Parking Lot Specialties Expansion – Site Plan

City of Carlisle, Iowa

FOX Engineering & City Staff have completed the second review for the Parking Lot Specialties Site Plan submittal dated 11/9/21 and submitted by email on 11/10/21 and offer the following comments:

Parking Lot Specialties – SITE PLAN - 210106

West Elevation

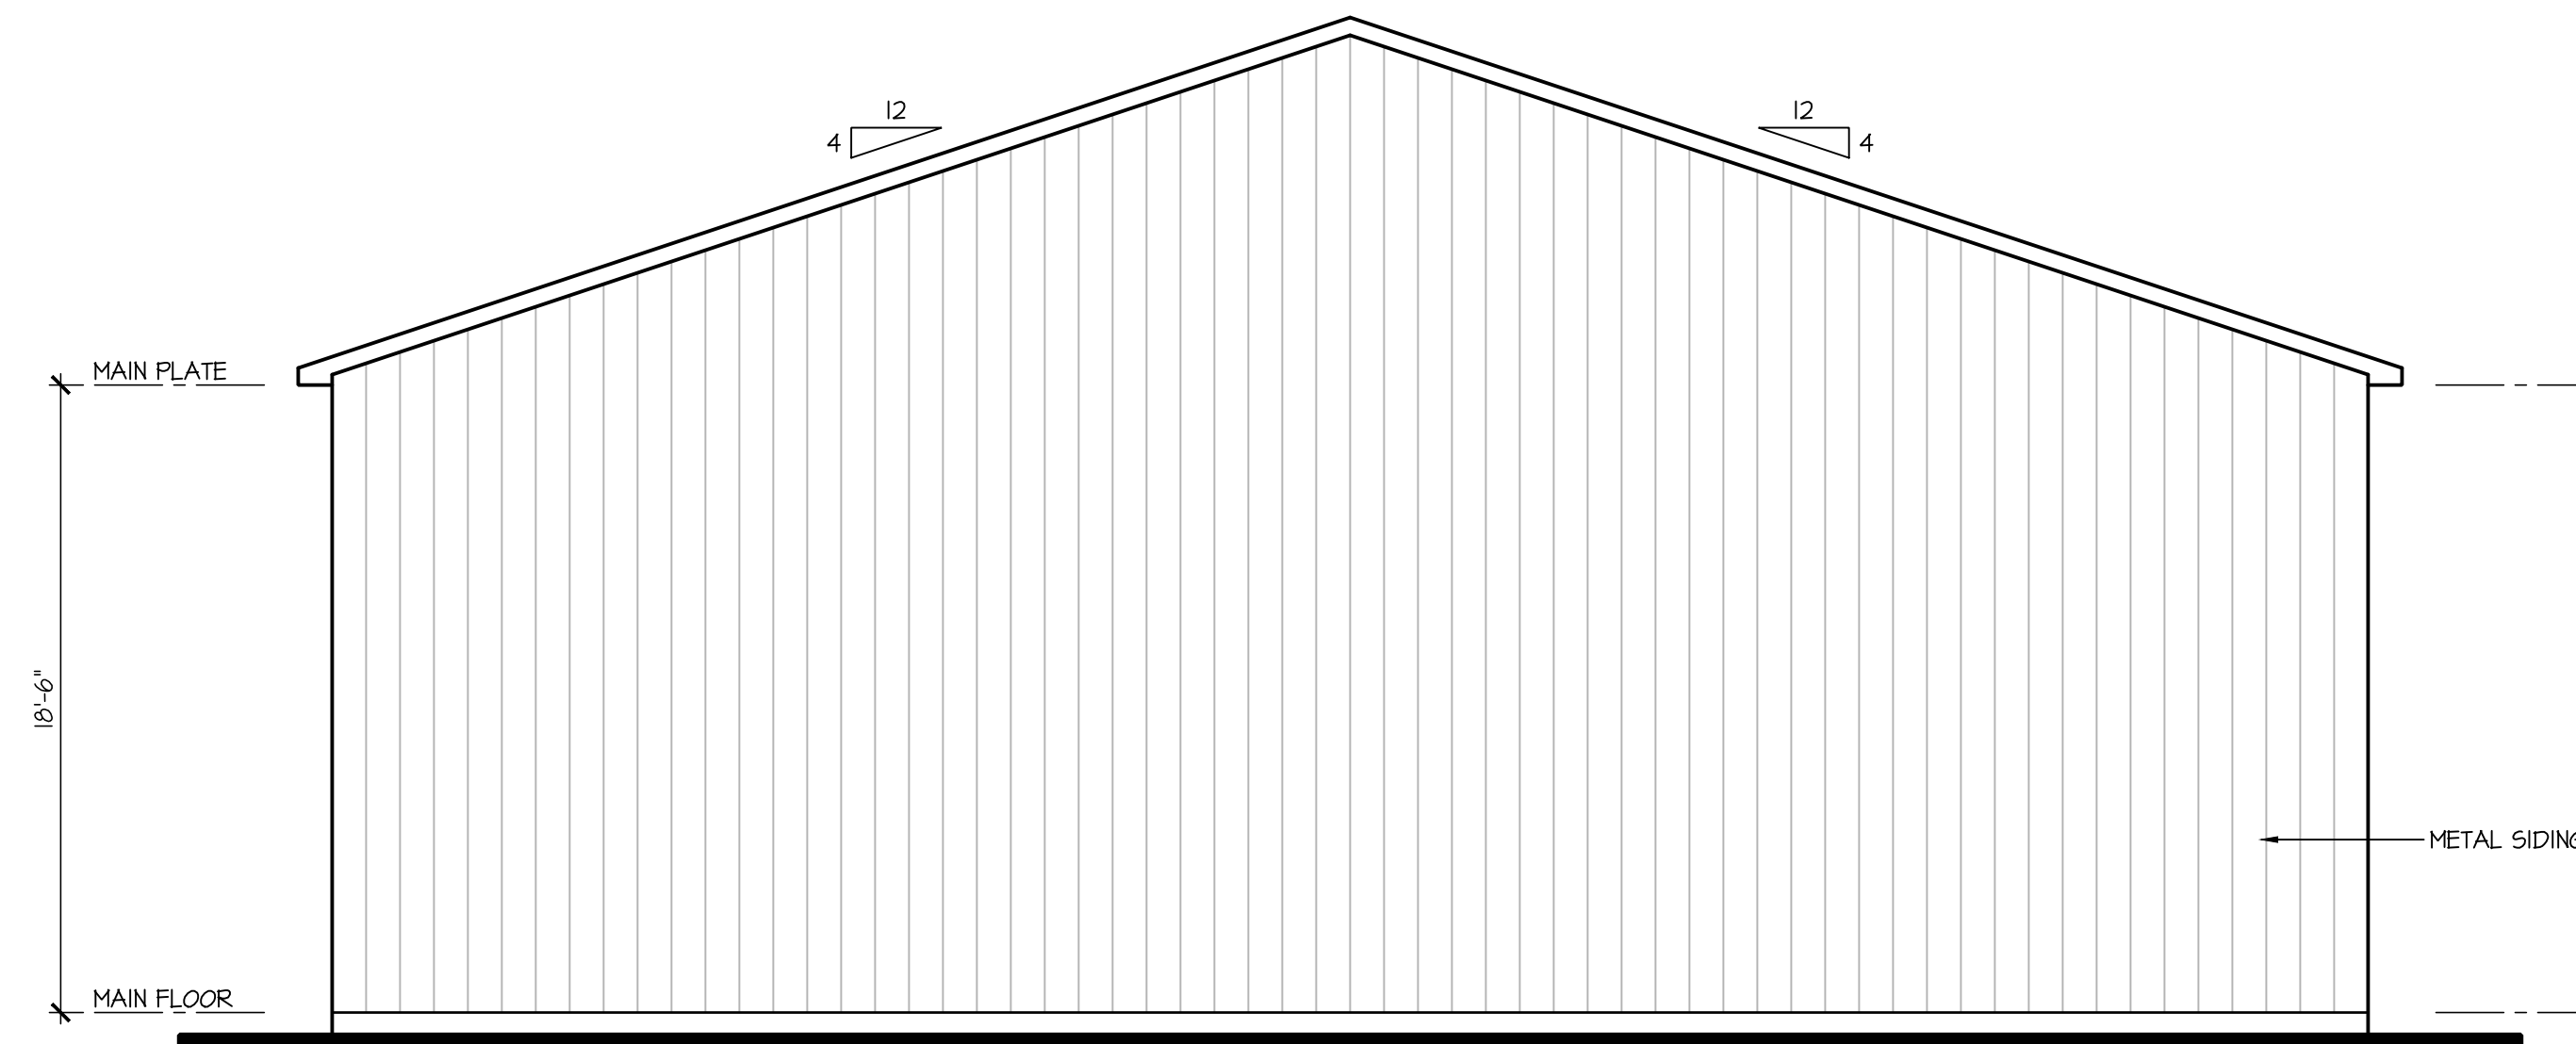
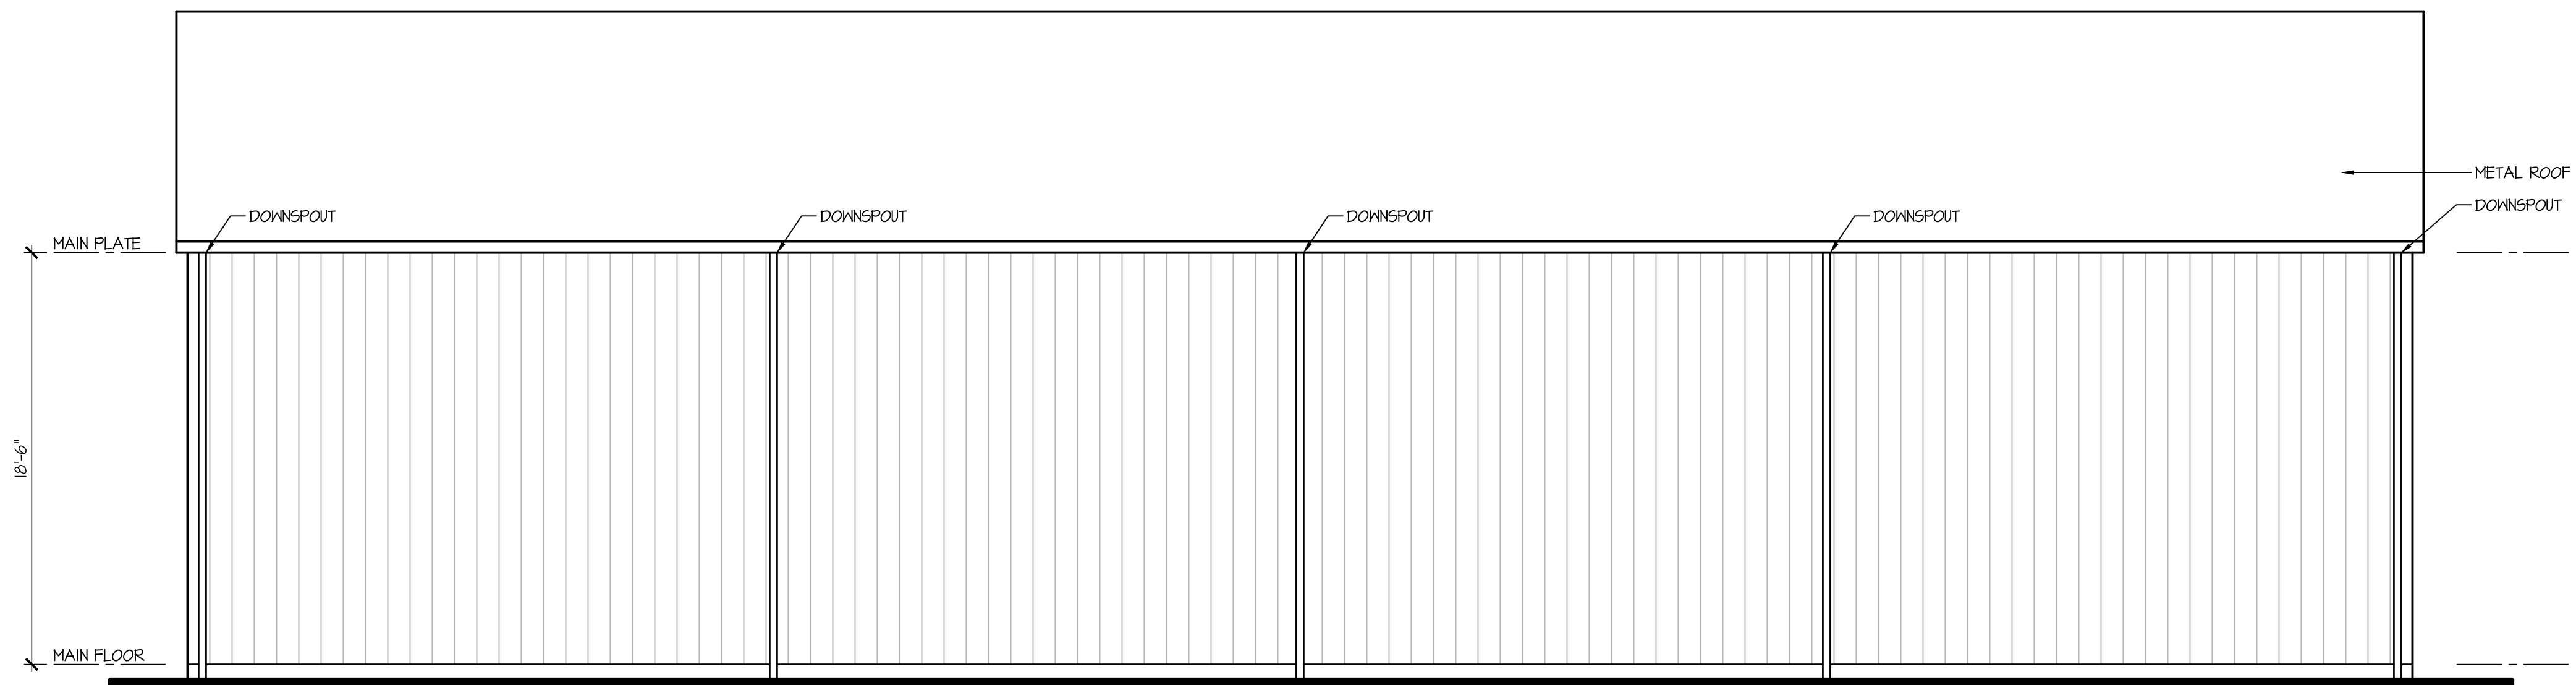
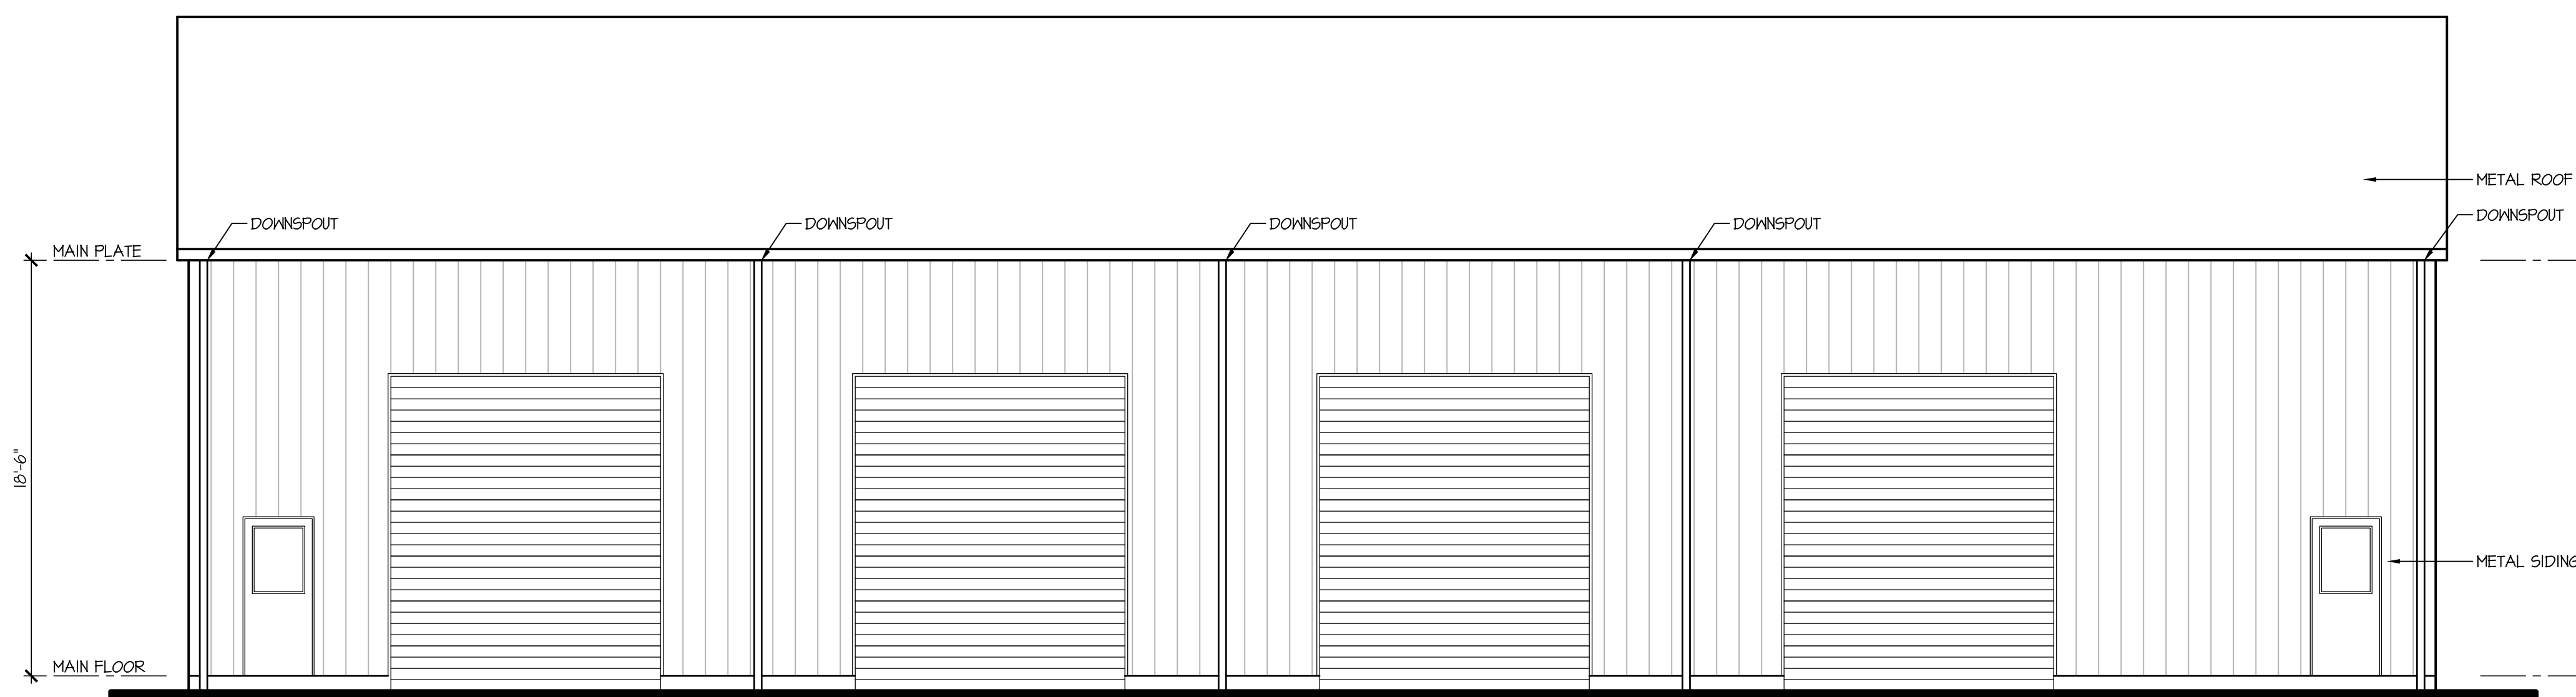
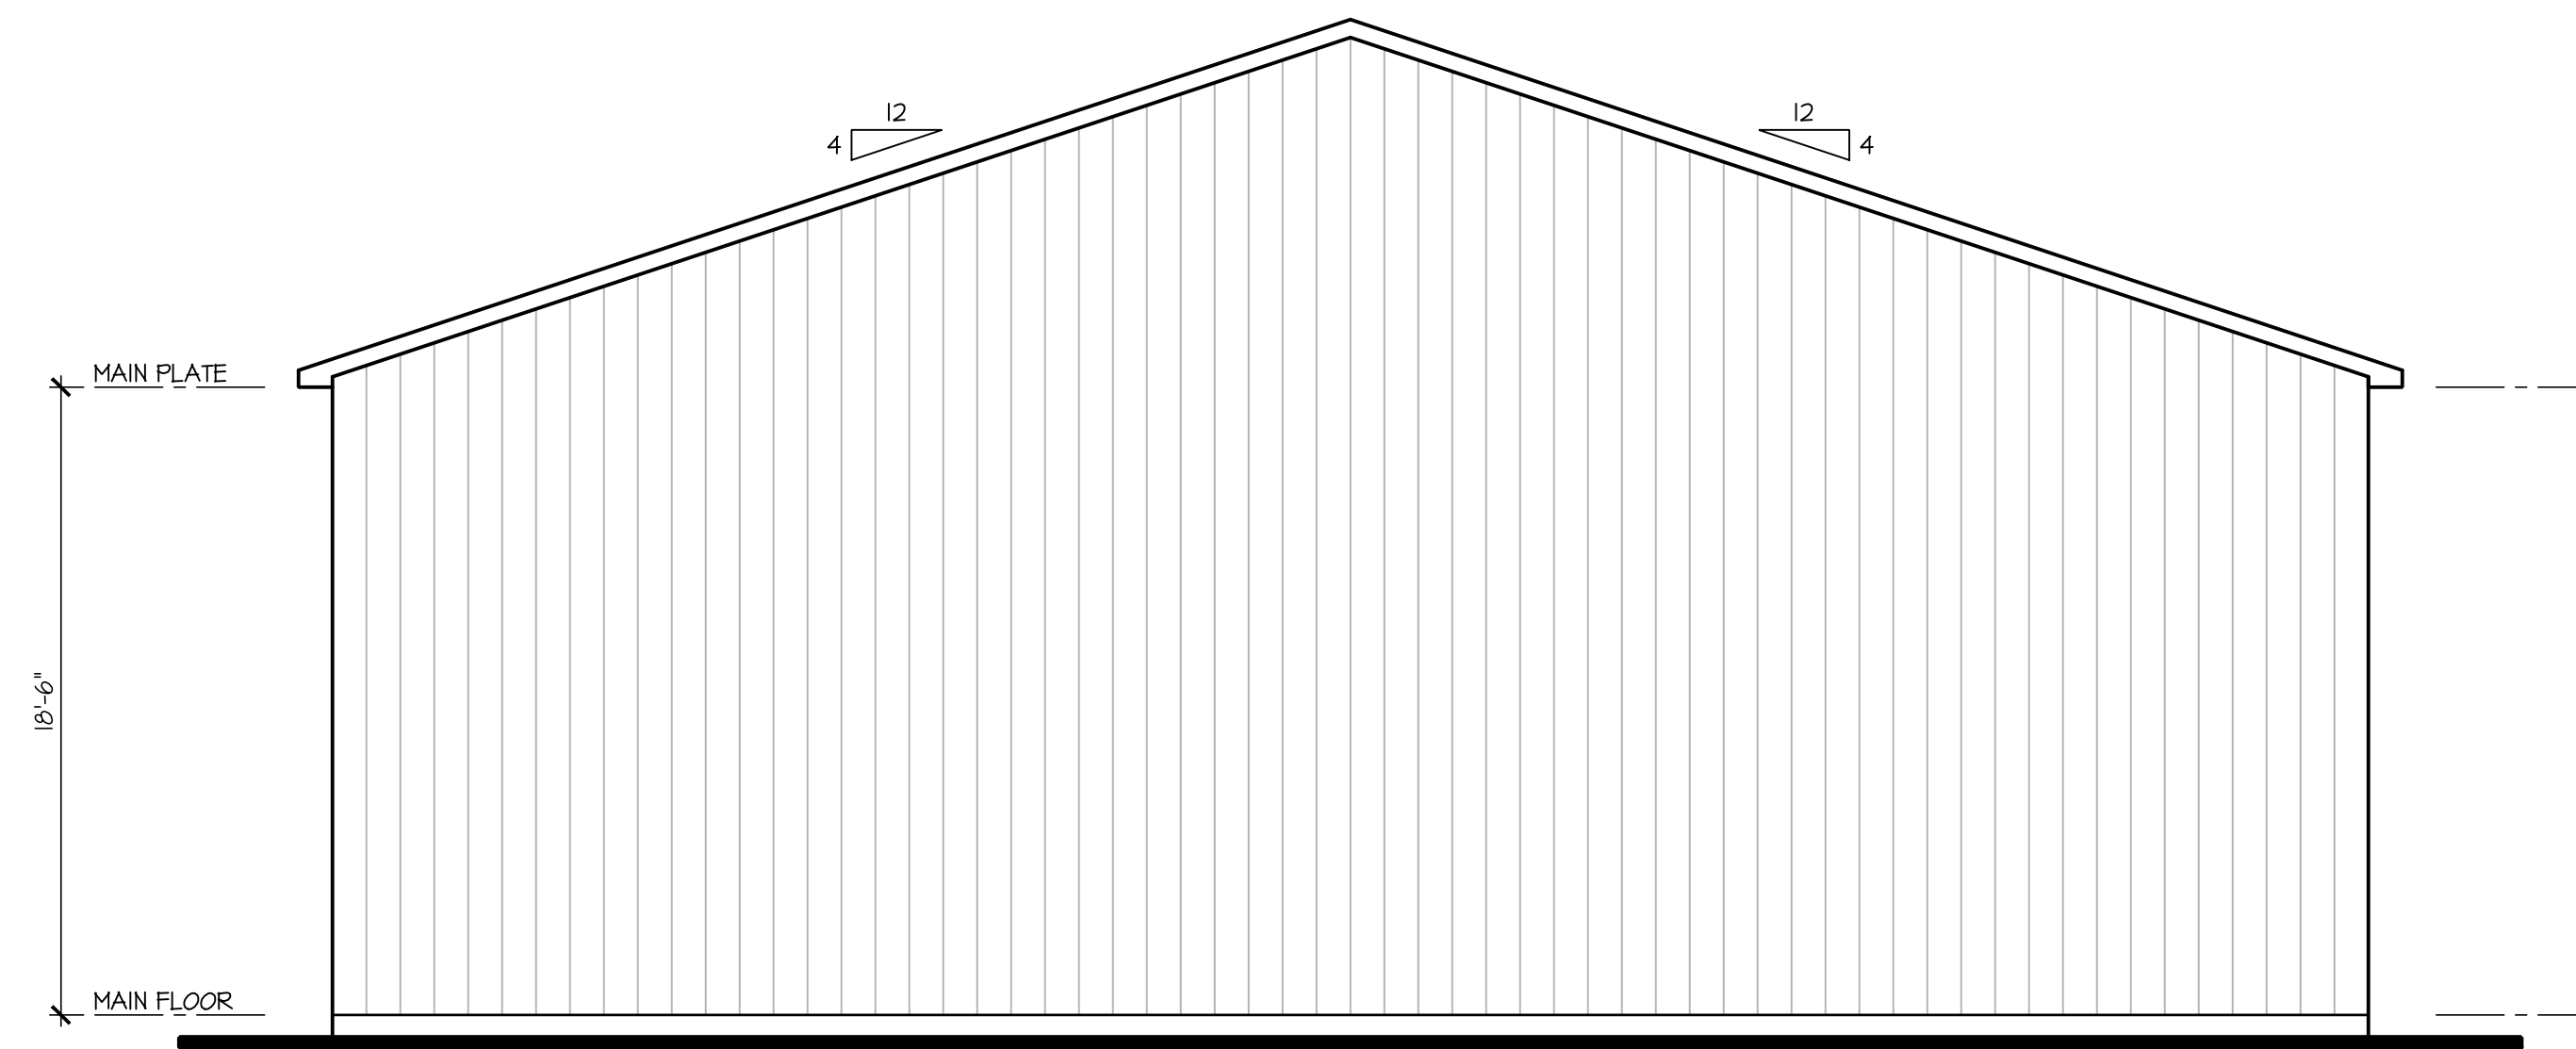
14. The west elevation shows a man door (NW corner) that is not shown on the site plan. Please revise as necessary.
15. Please state the color and type of building materials for all structures. Please clarify that this building will match the first structure.
16. It is highly recommended that you bring detailed building materials and color schemes with you to P & Z and Council for discussion.

32. The elevations have been corrected
33. The Owner will provide more information regarding color and building materials
34. We understand it is highly recommended to bring detailed building materials and color schemes to P&Z and Council for discussion
